# INDEPENDENT EXPERT ADVISORY PANEL FOR MINING

## **MOOLARBEN COAL COMPLEX OC3 Extension Project (SSD-330833580)**

**Report No: IEAPM 202504-01**

Figure 14: Effect of the Industry Safeguard Mechanism Baseline on MCC Emissions Intensity

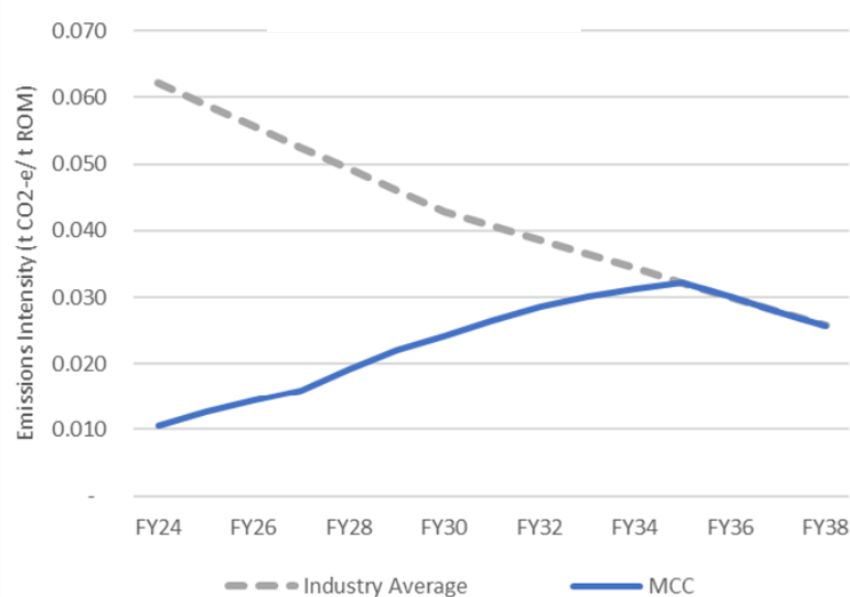
1. MCC's projected emissions intensity (EI) against the Safeguard mechanism baseline. For the duration of the project, the EI falls below the industry average, but with the earned Safeguard Mechanism Credits progressively reducing as MCC's EI is increased by including a greater proportion of industry average EI over time (Figure 14 - MCC presentation document to IEAPM 9/5/24). The GHGMP should take into account during review periods, any effect on MCC through potential changes in the Safeguard baseline due to legislation and the industry average EI performance over time.
